**DOCUMENT 00 90 00
ADDENDUM**

ADDENDUM NO. [2] Date: October 10, 2019

**RE: LANESBORO PUBLIC SCHOOLS
 ADDITION AND REMODEL REBID
 100 KIRKWOOD ST EAST
 LANESBORO, MN 55949
 HSR 18063**

**FROM: HSR Associates, Inc
 100 Milwaukee Street
 La Crosse, WI 54603
 (608) 784-1830**

E092P

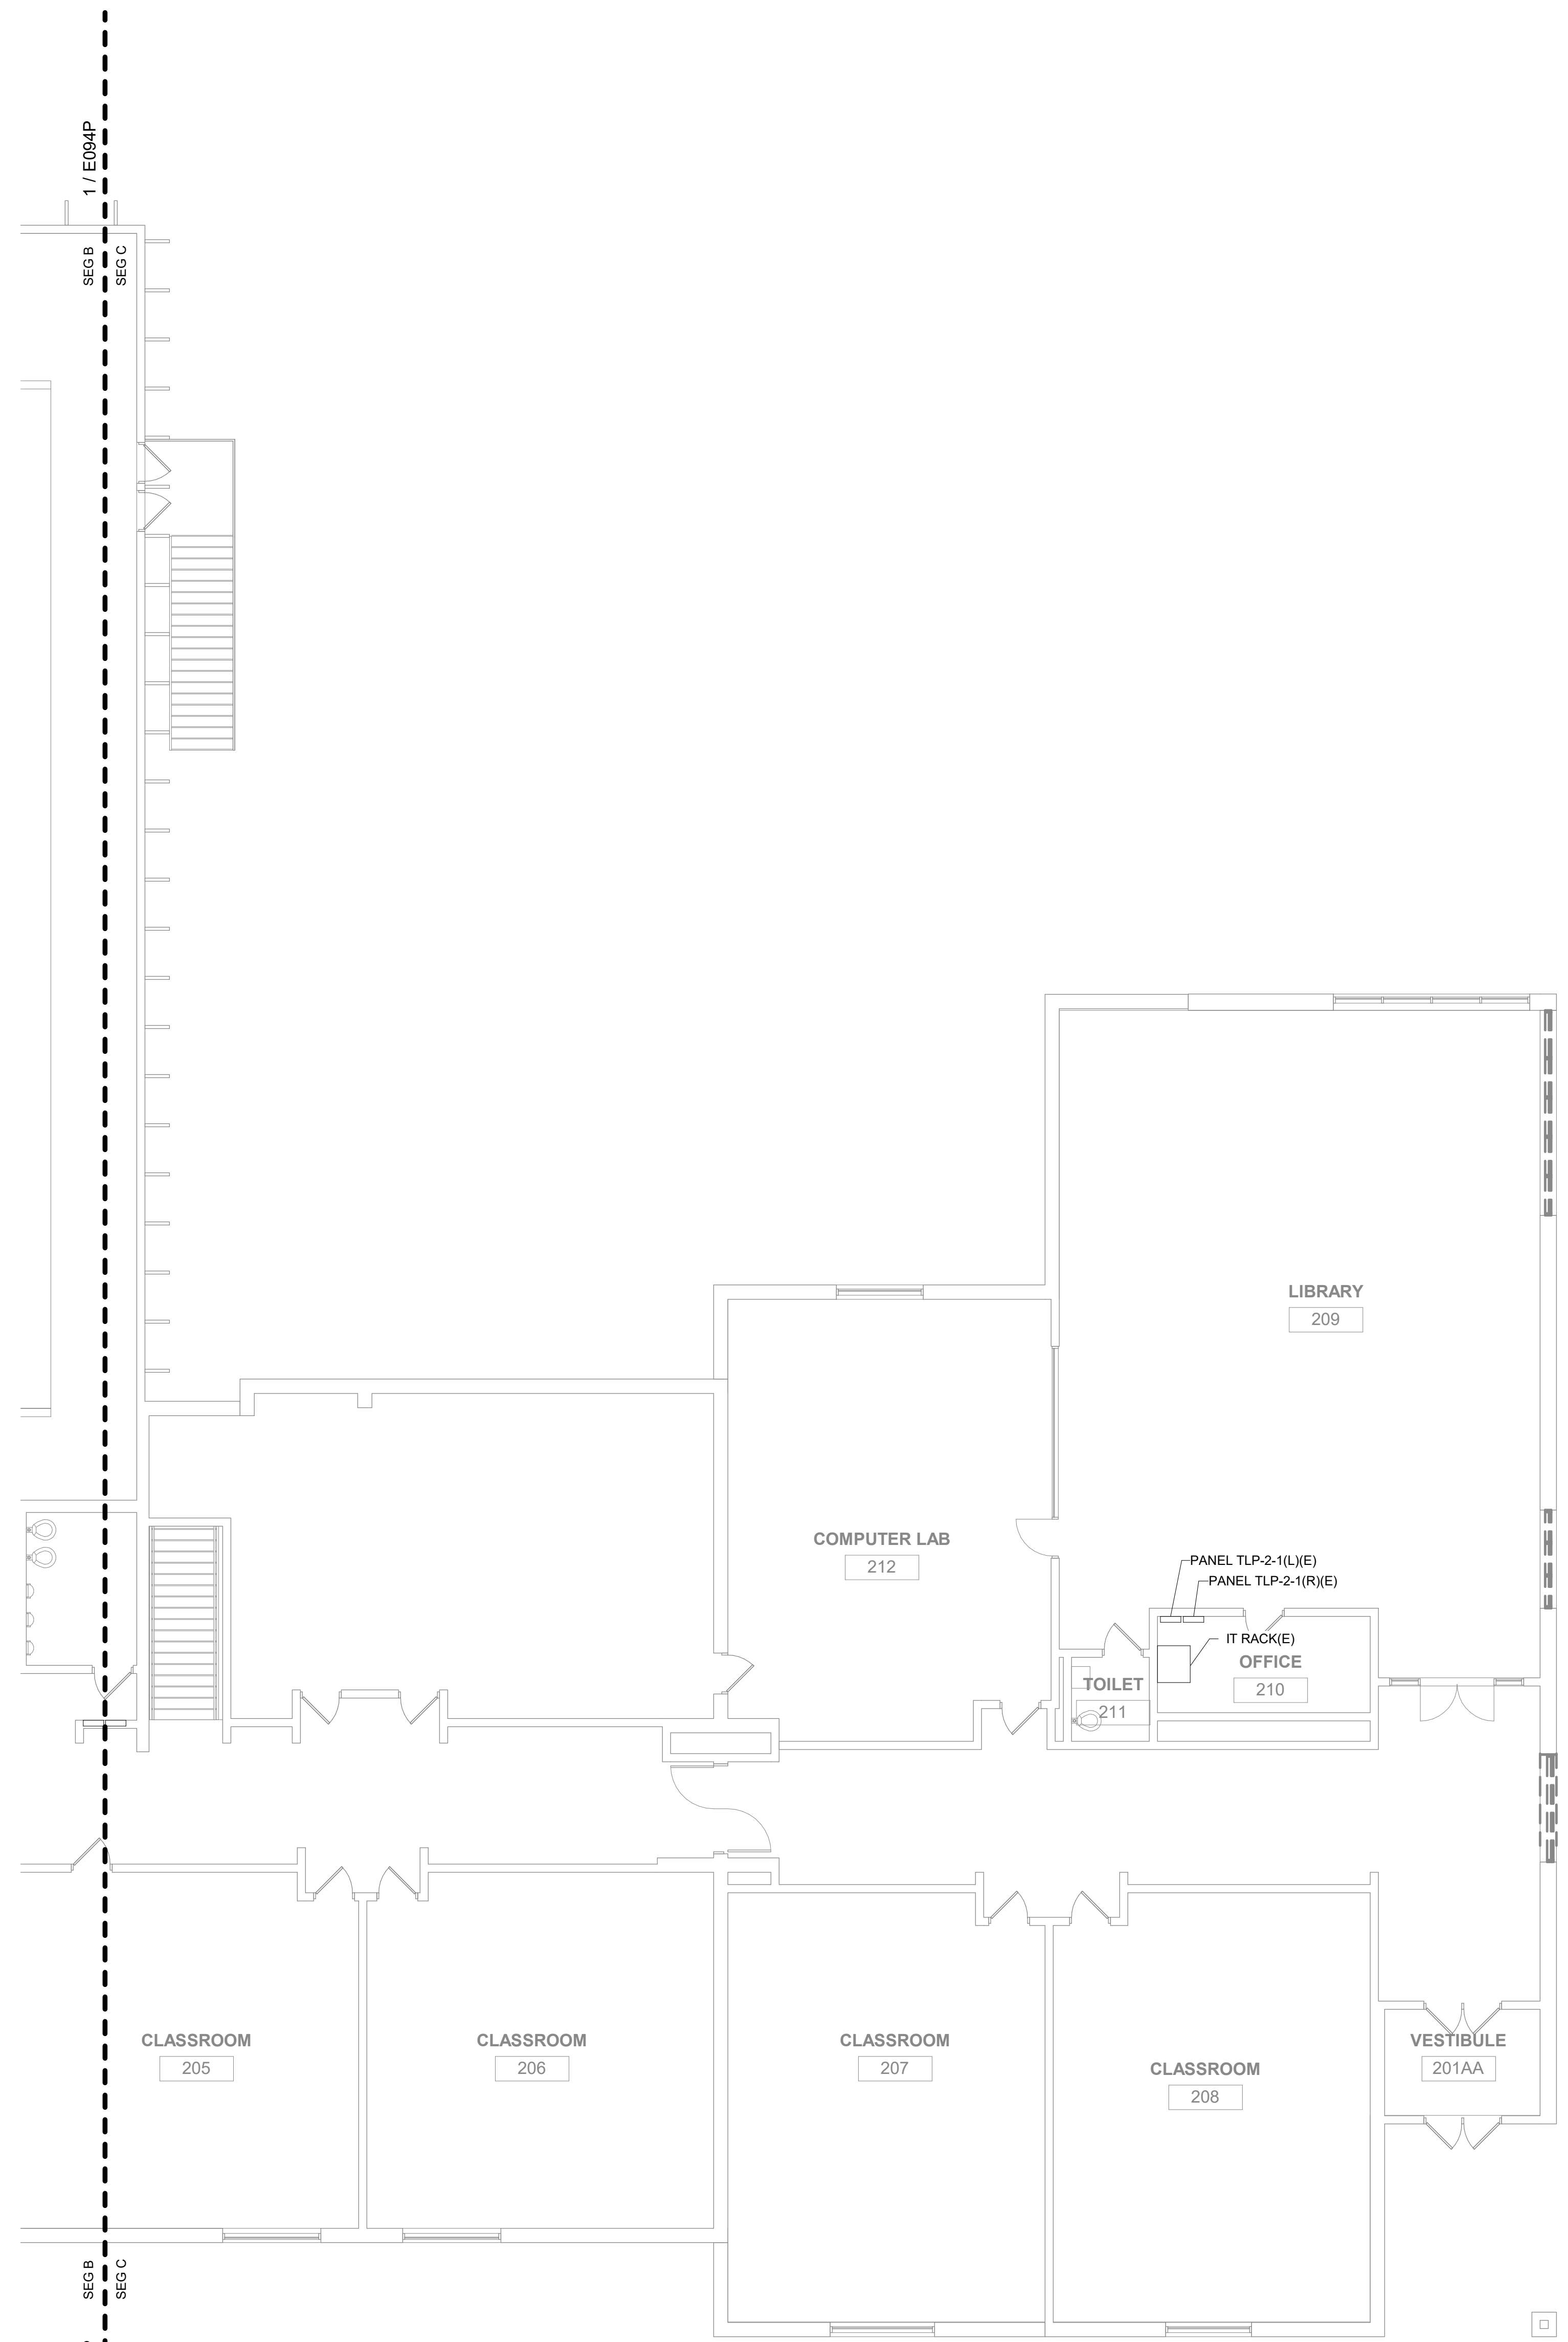
- a. Revisions clouded on Drawing
 - b. Revise keyed note 1 to clarify scope of work to be done for green house relocation, as shown.
55. Sheet E095P – UPPER LEVEL DEMO - SEG C – POWER/SYSTEMS 30 x 42 attached hereto

E095P

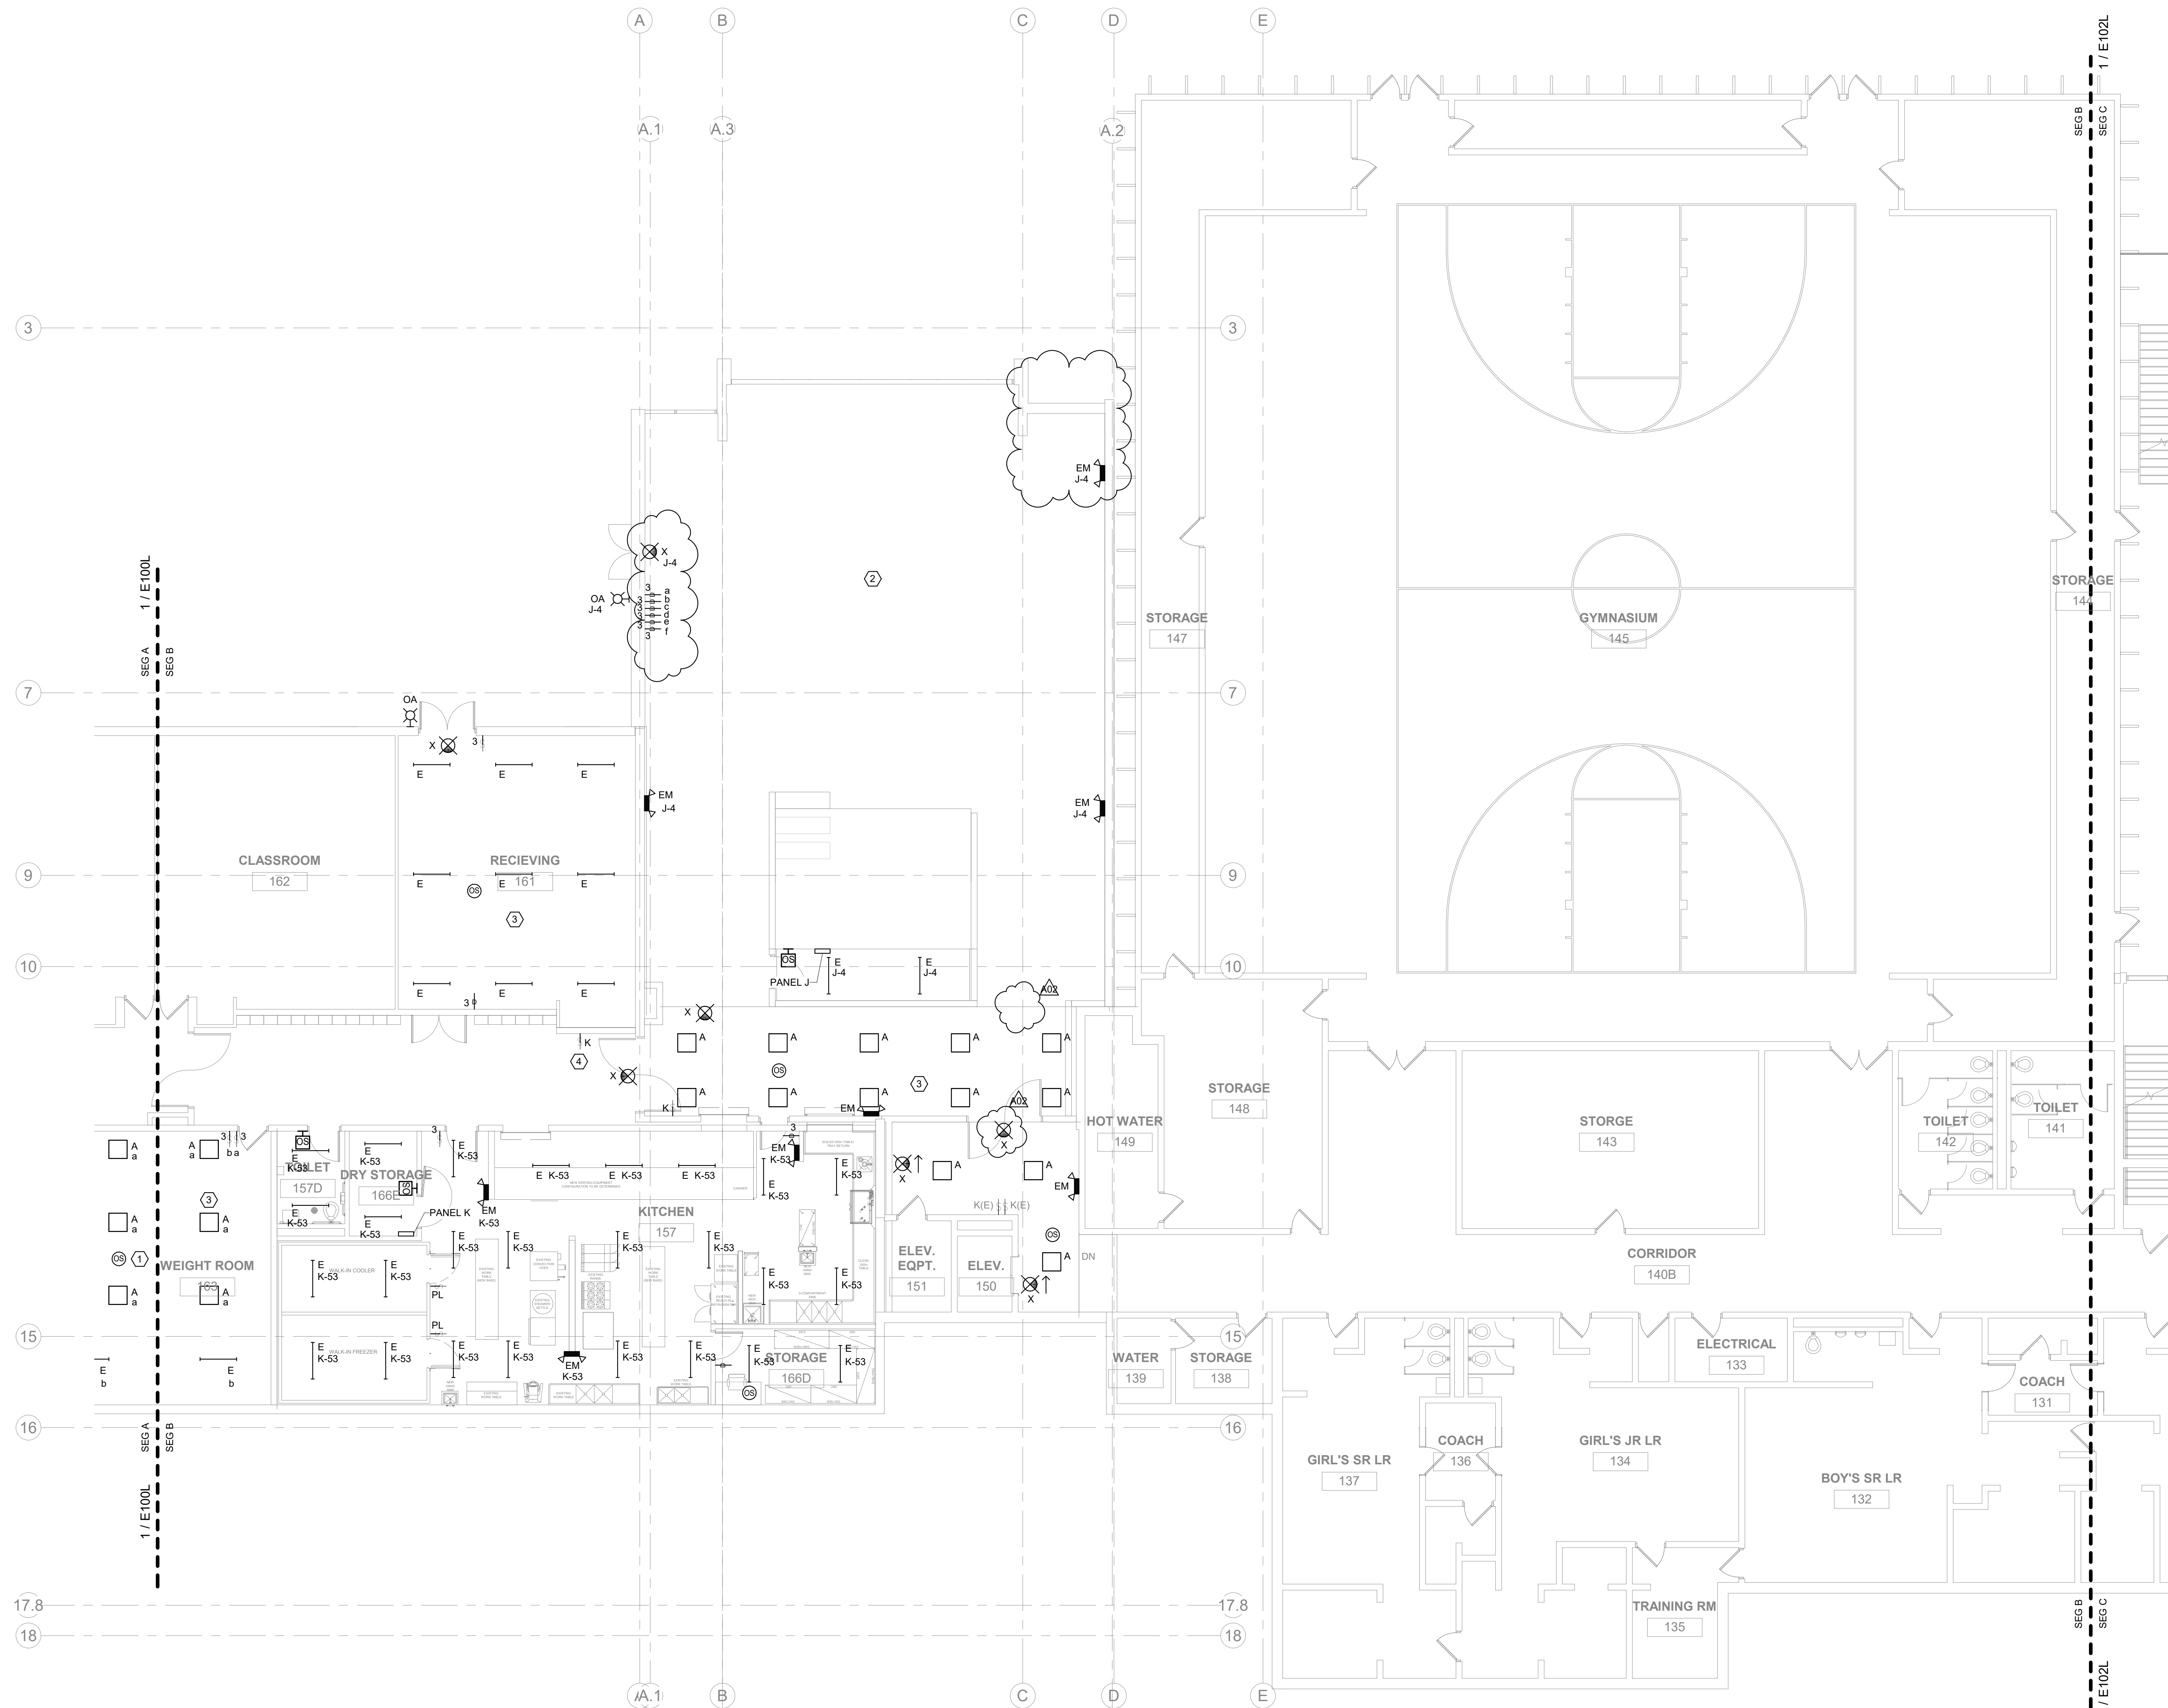
- a. Revisions clouded on Drawing
 - b. Revise keyed note 1 to clarify scope of work for new utility transformer and CT cabinet, as shown.
56. Sheet E101L – LOWER LEVEL - SEG B – LIGHTING 30 x 42 attached hereto

E101L

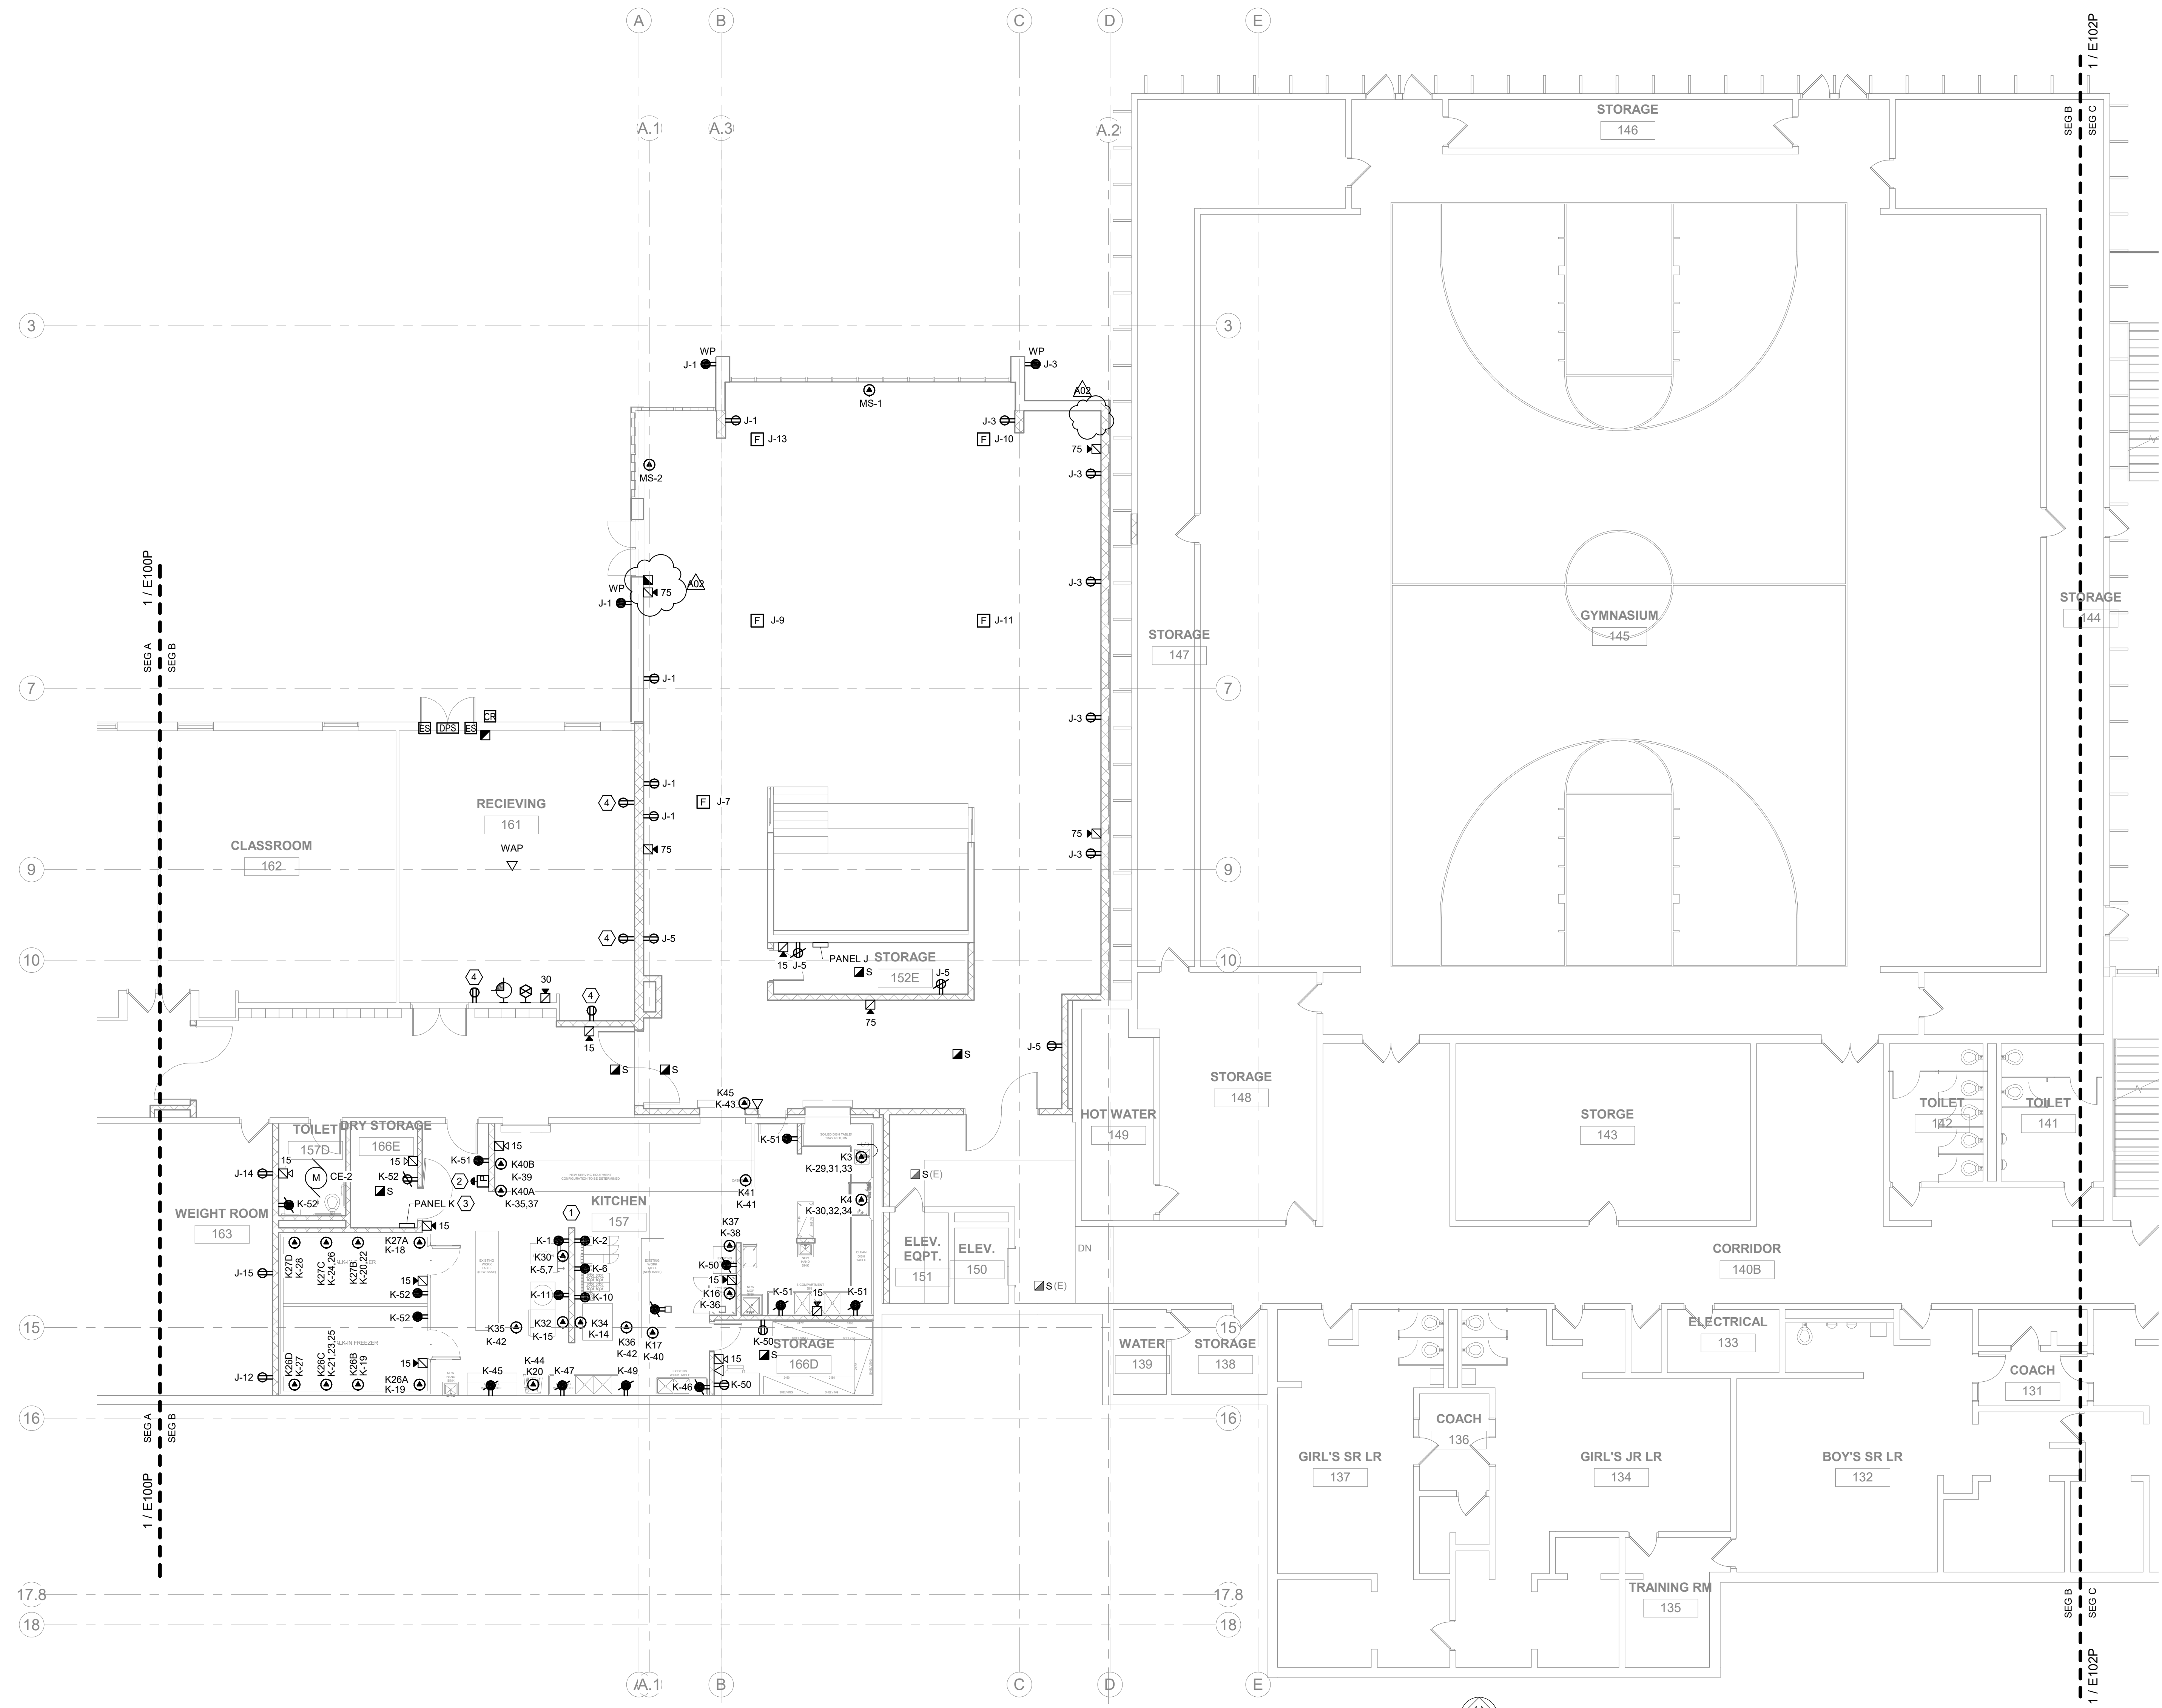
- a. Revisions clouded on Drawing
 - b. Revise lighting and lighting control devices per architectural changes, as shown.
57. Sheet E101P – LOWER LEVEL - SEG B – POWER/SYSTEMS 30 x 42 attached hereto
